TSG-RAN Meeting #25 Palm Springs, USA, 07-09 April 2004

RP-040369 Agenda item 7.3.5

Title: Removal of the DCCH mapping on HS-DSCH: CRs on 25.301, 25.308 and 25.331 (Rel-5, Rel-6)

Figure 5.2.2.1-1: Model of the UE's Downlink physical layer - HS-PDSCH with associated DPCH. HS-PDSCH is transmitted from cell 1 in this figure

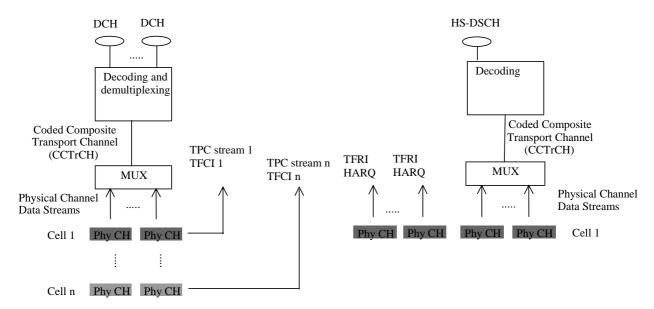
•		ns of the above	categories	can		Rel-4	(Release 4)		
be	e found in 3	GPP _	TR 21.900				Rel-5	(Release 5)		
							Rel-6	(Release 6)		
Reason for change:	ж <u>1.</u>									
		oclaus	e 5.2.2.1 it is	stated tha	DC0	СНс	an be mappe	ed to the DCH	or the	
								mapping DCC		
								FDD mode and		
			uirement for th

Clause 4 (Figure 5.2.2.1), Subclauses 9.4 and 9.5.

The upper layer signalling on the DCCH can be mapped to the DCH mapped to the associated DPCH, or <u>in case of TDD</u>, to the HS-DSCH.

Figure 9.4-1: Inter-Node B synchronised serving HS-DSCH cell change during hard handover

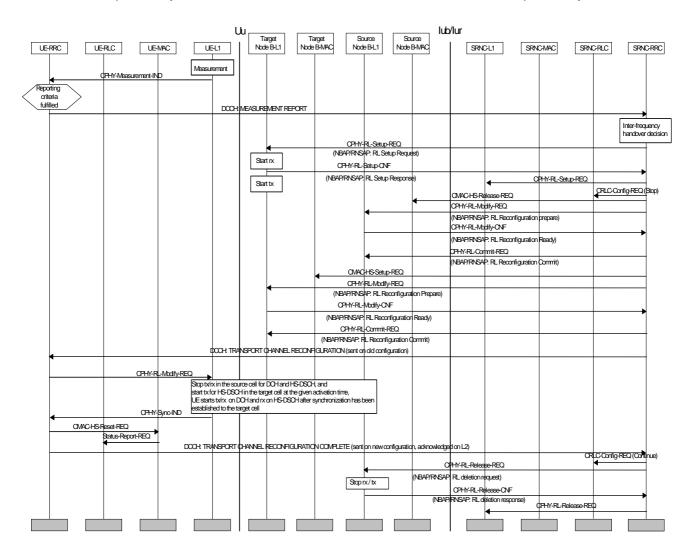
2.									
								flag for MAC-h		
	(i.e. "I MAC-		ns reset indica	tor). Ther	e MA	C-sł	n is incorrectly	y mentioned in	stead of	
	3.									
		In section 9.5 TRANSPORT CHANNEL RECONFIGURATION is erroneously mentioned as a response message from UE to network.								
	menti	oned	as a response	message	trom	ı UE	to network.			
Summary of change:	光 1. The	e sent	ence is made	TDD spec	ific. 1	thus	this mapping	option is remo	oved from	
	FDD.				,				22.7.2.11	
	<u>2. and</u>	<u>3.</u> TI	ne above item	s are corre	ected	l in e	ach section.			
Consequences if	器 Incon	eietan	cy and incorre	otnace w	י אווע	ama	in in the ener	rification		
not approved:					Julu I	CIIIO	un in the spec	omballott.		
	Impa No im		test specifica	tions:

The SRNC then sends a TRANSPORT CHANNEL RECONFIGURATION message on the old configuration. This message indicates the configuration after handover, both for DCH and HS-DSCH. The TRANSPORT CHANNEL RECONFIGURATION message includes a flag indicating that the MAC-sh-hs entity in the UE shall be reset. The message also includes an update of transport channel related parameters for the HS-DSCH in the target HS-DSCH cell.
